CHENA LAKE RECREATION AREA BICYCLE & PEDESTRIAN ACCESS PROJECT

Public Comments and Responses as of March 12, 2025

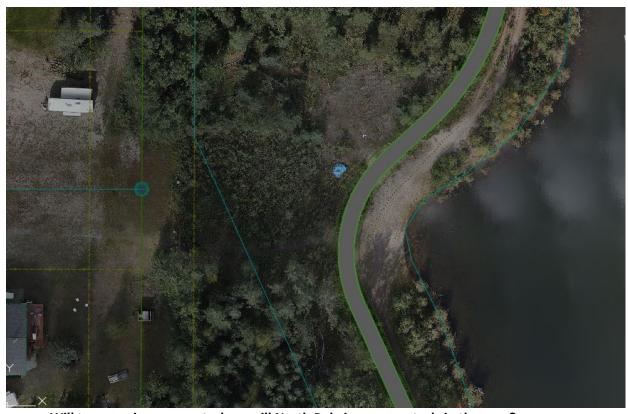
What steps will be taken to stop the opened beach area at Lakewood Loop from being used?

Regarding the open beach area, below is a screen shot of our proposed path alignment near the area we believe you are referring to. Areas around the path embankment will have to be seeded to reduce erosion potential, and that will include a portion of this area. While no specific action is being taken to modify the shoreline, we can evaluate if additional vegetation makes sense.
